Name: Fayette County Health Department
Building Renovations

A2H #: 23406

Addendum #: 1

Date of Issuance: 7/12/24

D3 FLOOR PLAN - FINISHES
3/16" = 1'-0"

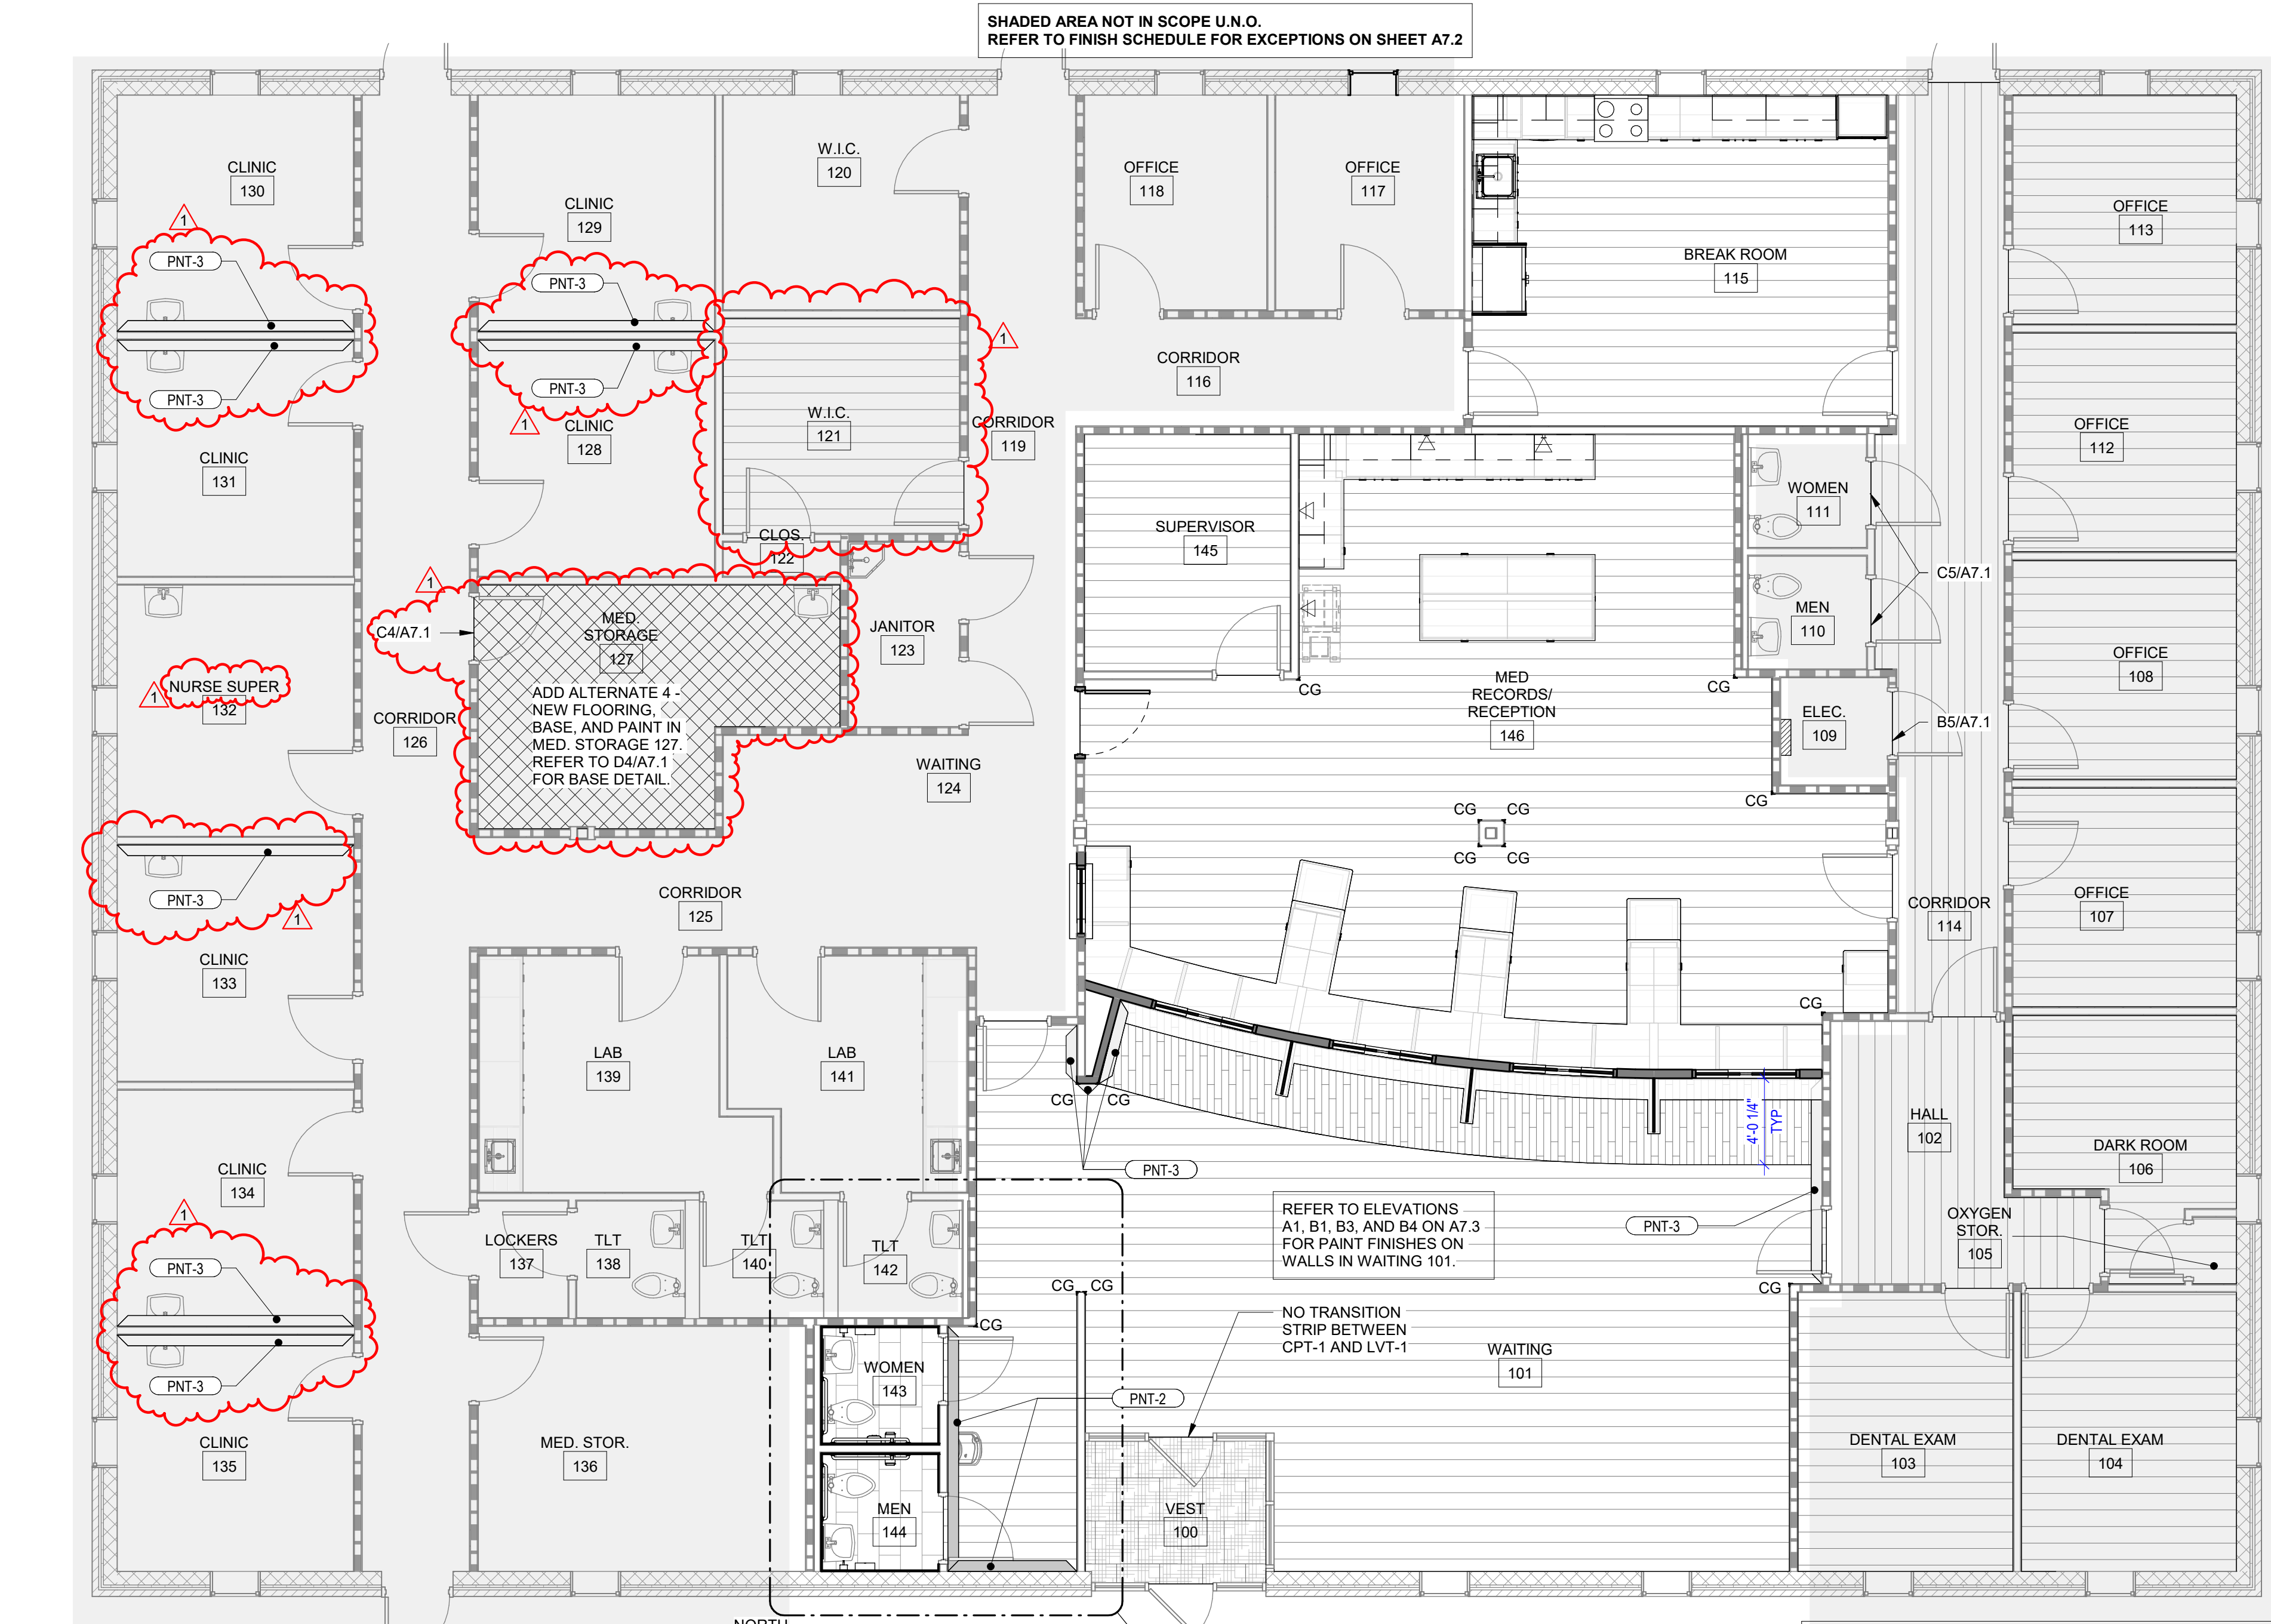
- a. Clouded name to room number 132 changed to NURSE SUPER.
 - b. Add lines through deleted finishes from Finish Schedule and Material Schedule.
 - c. Add clouded PNT-3 accent wall designation to CLINIC 128, 129, 130, 131, 133, 134, 135.

- d. Add clouded notes and flooring hatch to MED. STORAGE 127.
 - e. Add clouded flooring hatch to W.I.C. 121.
 - f. Add clouded cross hatch and designation SV-1 to FINISH LEGEND.

B4 TRANSACTION TOP AT OPENING SECTION DETAIL
1" = 1'-0"

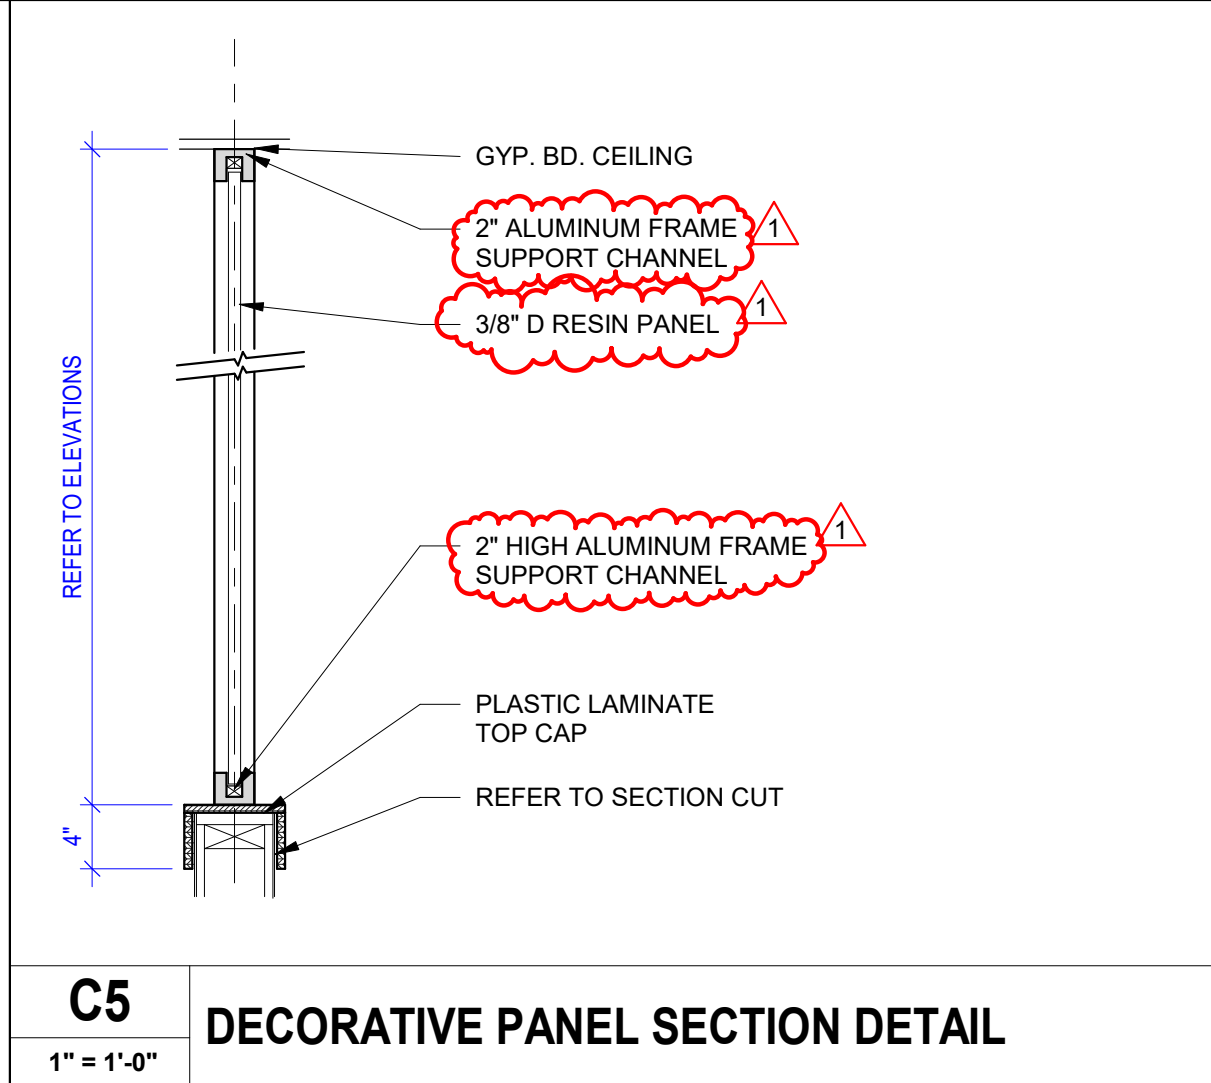
9. Clarity is needed on materials used in the reception desk millwork. A7.6 (D5, B4, B5) specify "Solid Surface Cladding" around the windows and wing panels. Will the windows be glass / with metal storefront framing? Is the cladding ½" acrylic cladding around the store front framework? If so would the acrylic be a cladding wrap or would there be an actual jamb liner that the metal framework rests on?

6. A7.6 – INTERIOR SECTIONS AND DETAILS
 - a. Clouded change to note on section detail B4 TRANSACTION TOP AT OPENING SECTION DETAIL.
 - b. Clouded changes to notes on section detail B5 TRANSACTION TOP AT FRAME SECTION DETAIL.
 - c. Clouded changes to notes on section detail C5 DECORATIVE PANEL SECTION DETAIL.
 - d. Clouded change to note on plan detail D5 DECORATIVE PANEL DETAIL.
7. A8.1 – REFLECTED CEILING PLAN
 - a. Add clouded note regarding base bid for new diffusers for existing lighting, BASE BID - PROVIDE AND INSTALL NEW LENS COVERS (MATCH EXISTING TYPE) FOR ALL EXISTING TO REMAIN LIGHTING FIXTURES IN ALL ROOMS SHOWN IN SHADED AREAS.
 - b. Clouded name to room number 132 changed to NURSE SUPER.

RESPONSE: THESE WINDOW FRAMES WILL BE CLEAR ANNODIZED ALUMINUM. REMOVE SOLID SURFACE CLADDING FROM ALL DETAILS.
